Mr. Dwight Russell, P.E.
Municipal Solid Waste Permits Section – MC 124
Texas Commission on Environmental Quality
12100 Park 35 Circle; Bldg. F
Austin, Texas 78753

Re: Pescadito Environmental Resource Center - Webb County
Municipal Solid Waste (MSW) Permit Application No. 2374
Notice of Deficiency - Technically Complete Permit Application Supplement Number 5
Tracking No. 21876231; CN603835489/RN106119639

APTIM Environmental and Infrastructure, Inc. is in receipt of your letter dated October 23, 2017 in which you are asking for additional information and clarification related to our submittal of August 17, 2017.

WASTE DISPOSAL, PROCESSING, AND STORAGE PLAN

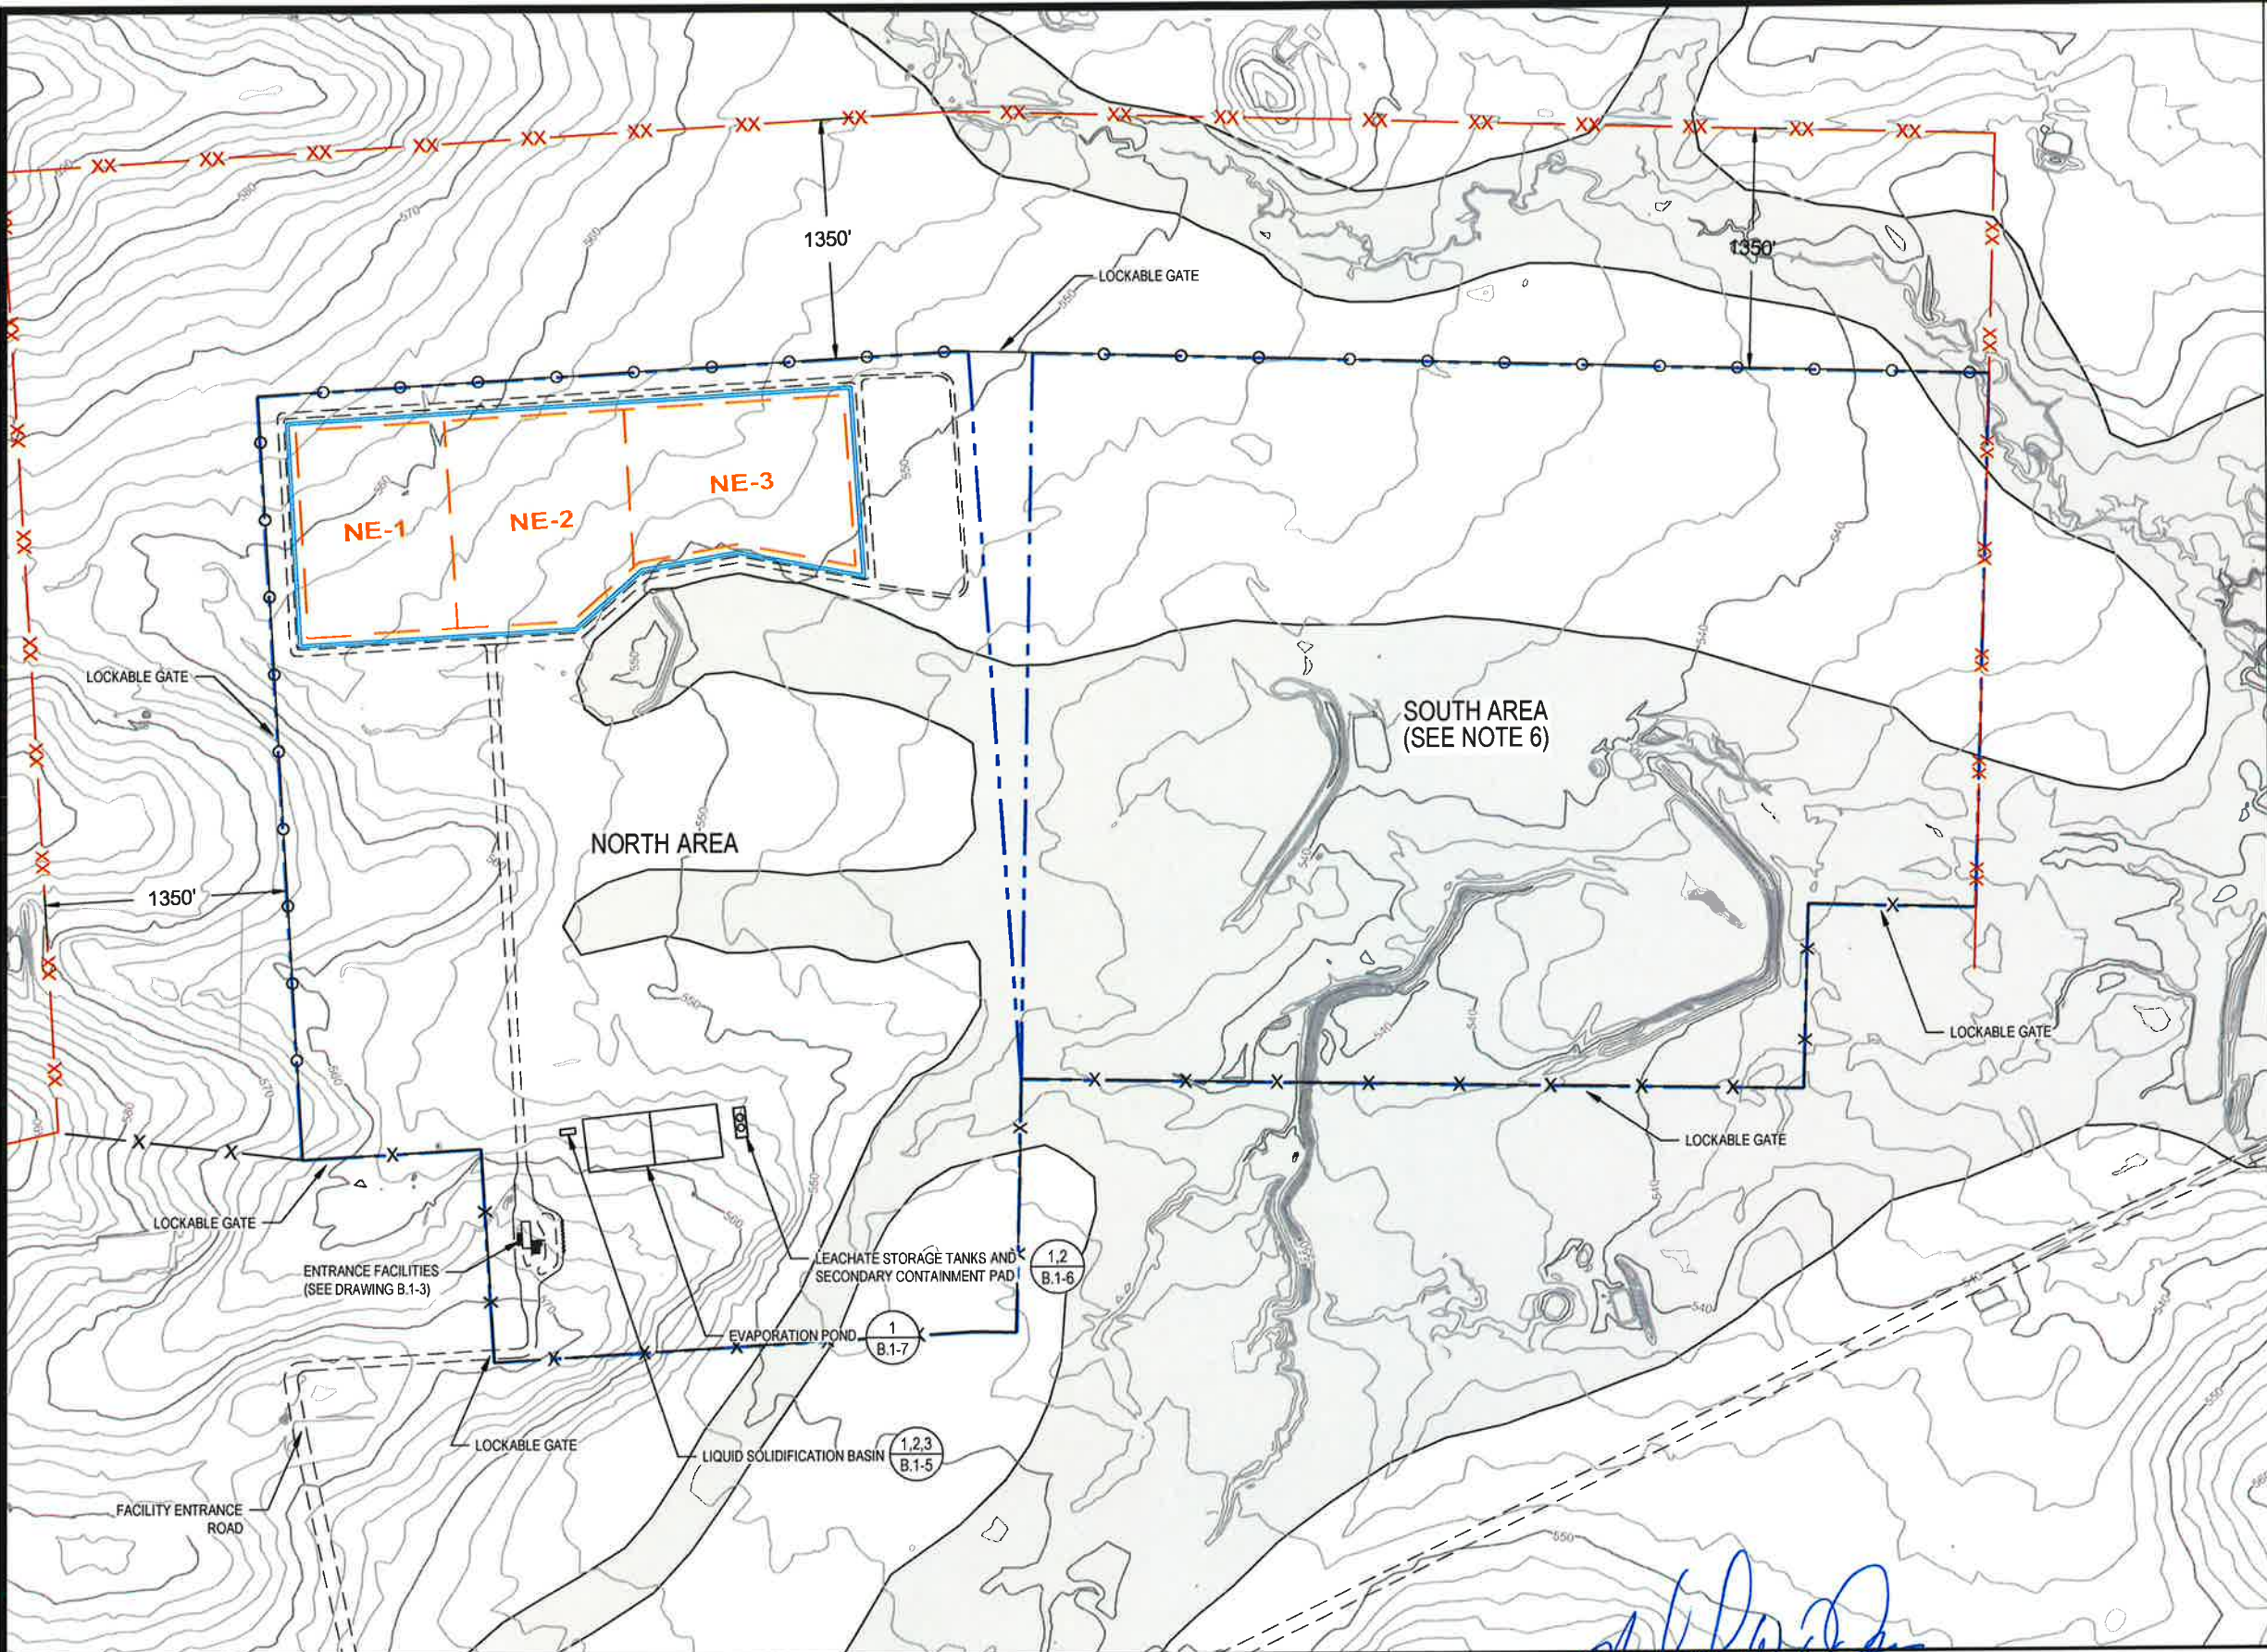
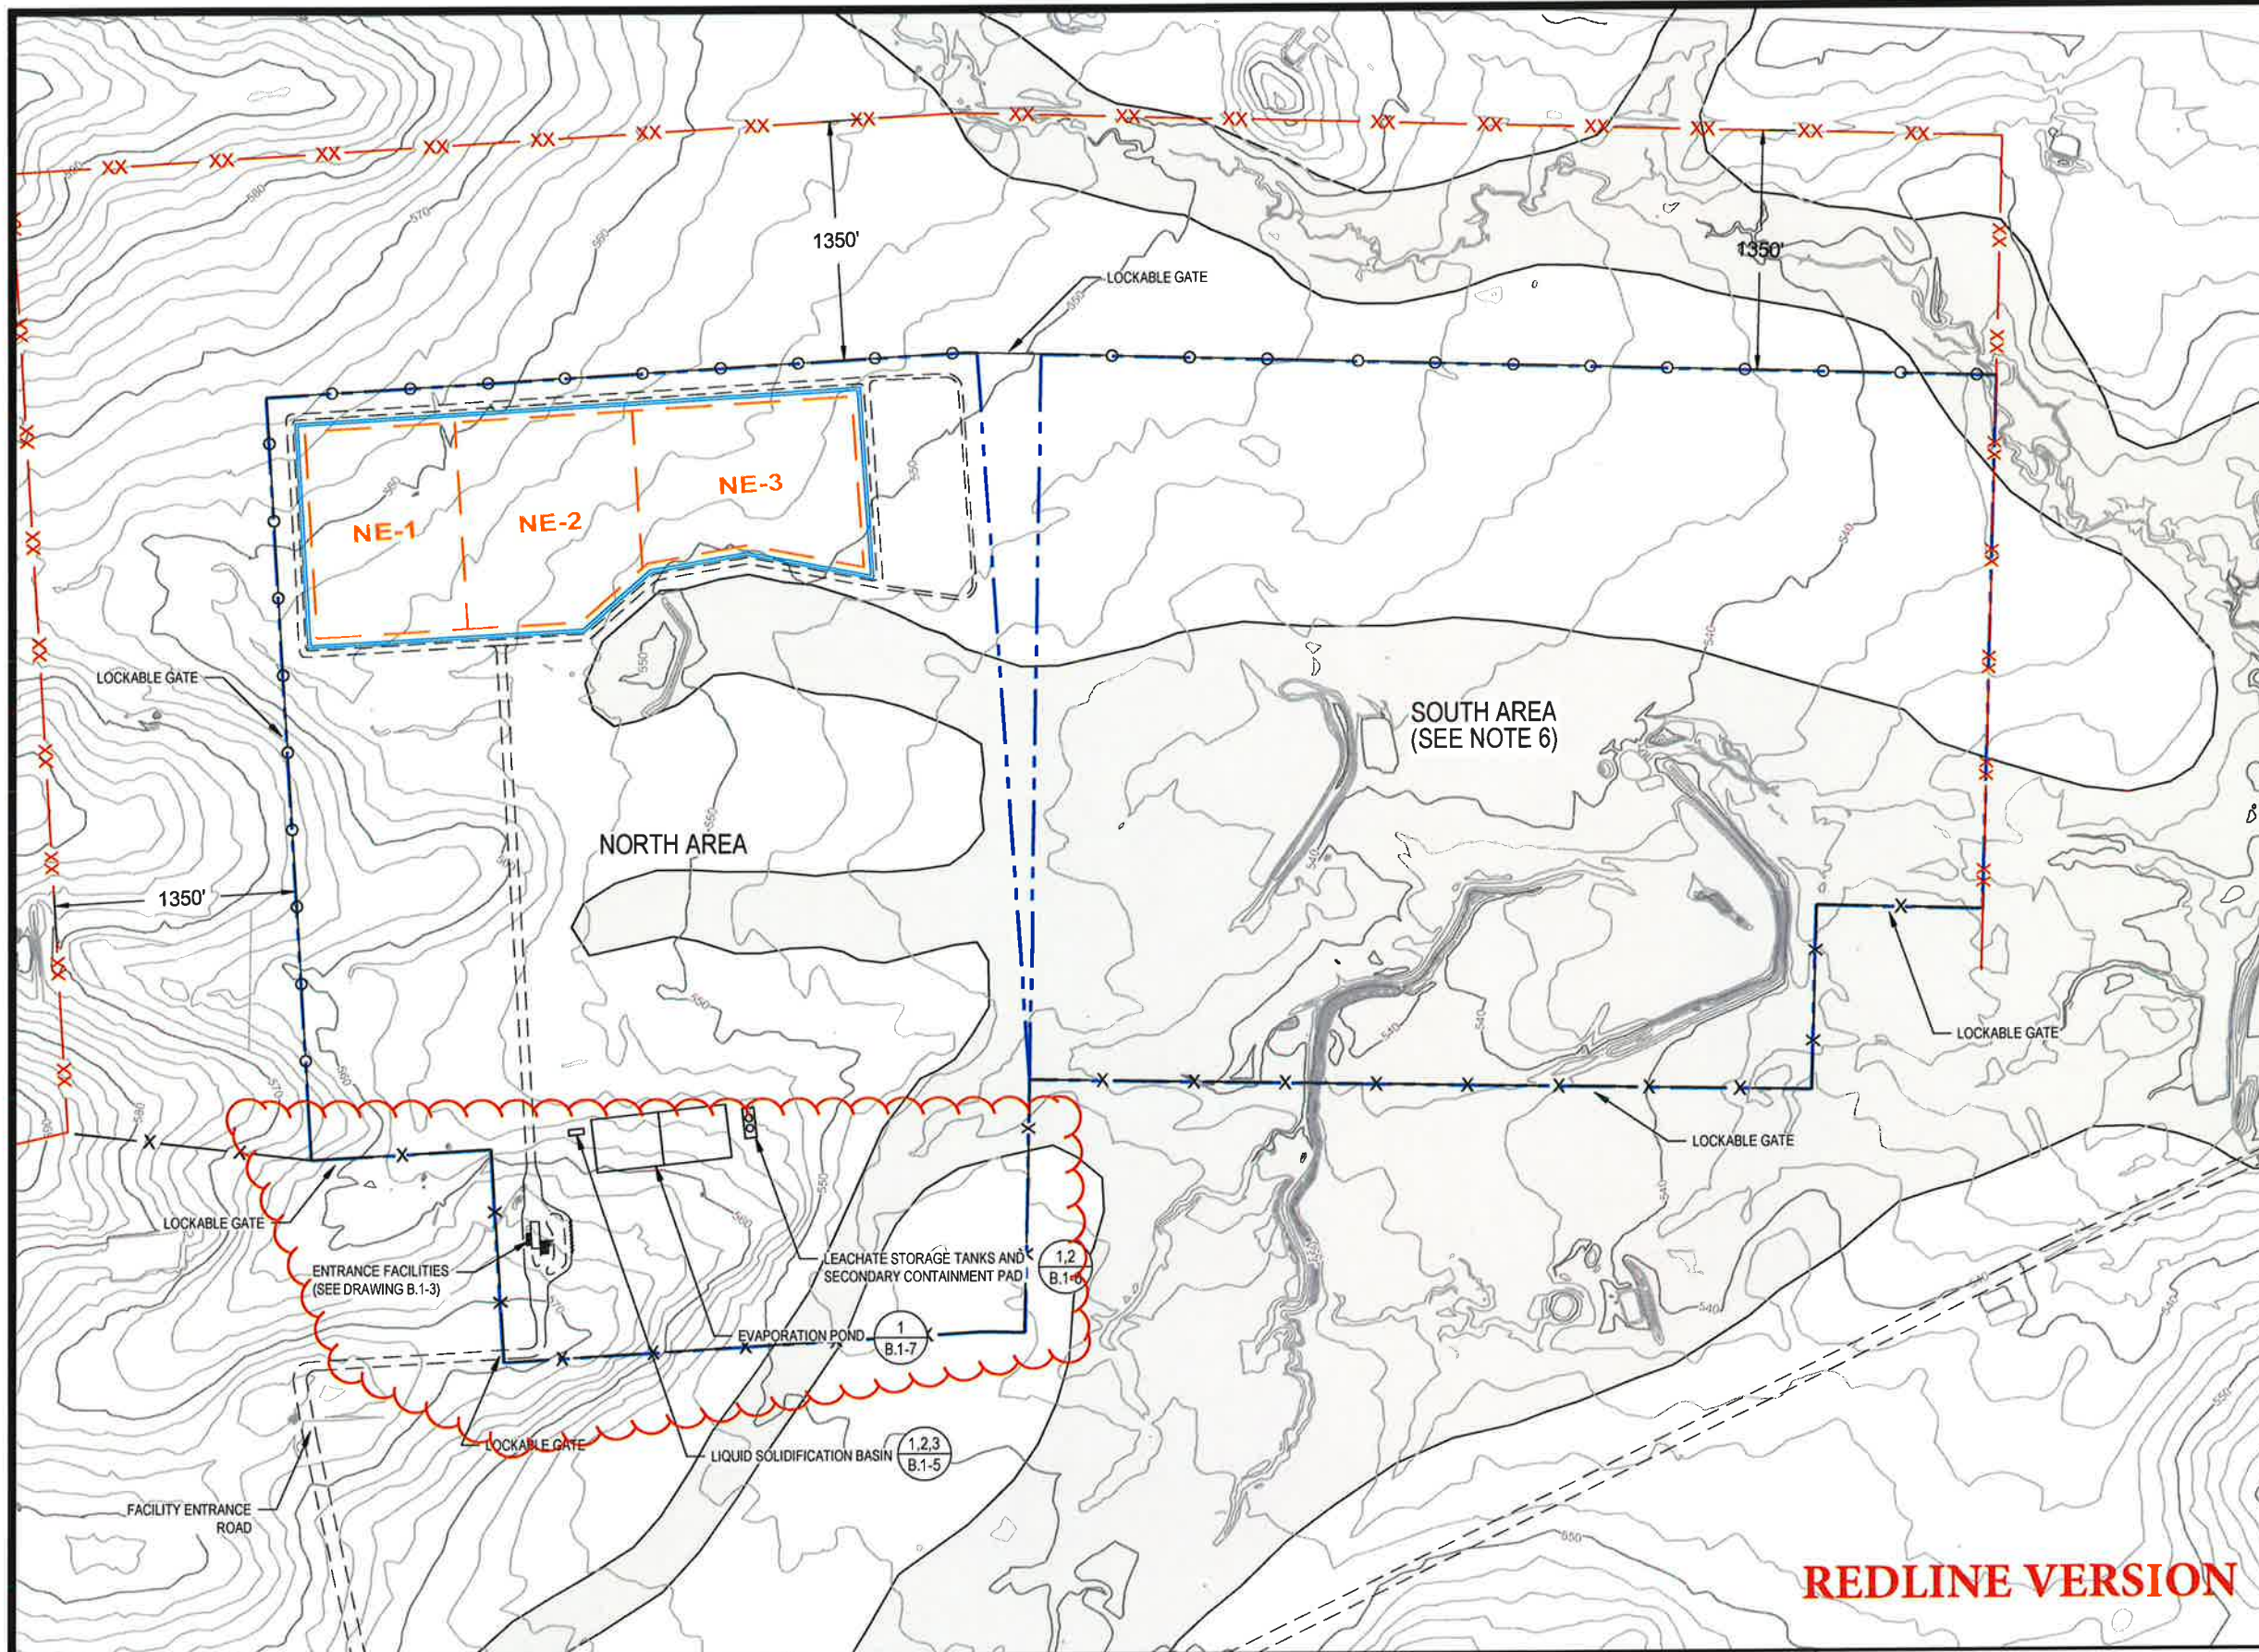
- 2) Part II, Figure 4 shows a fence running north/south just east of the gate house/scale area. This fence intersects the buffer zone and there is no perimeter fence tied into the entrance road gate. Please revise Figure 4 to clearly show all fencing and gates that are to provide security per §330.131 and comply with §330.141(b) regarding safe passage for emergency vehicle traffic.

Part II, Figure 4 is not intended to show the site access control features. Access control features are discussed in Part III, Attachment III-B on Page 1 and are shown on Drawing III-B.1-2 in Part III, Appendix III-B.1. That figure has been updated as requested. Additionally, the text in Part II has been modified to
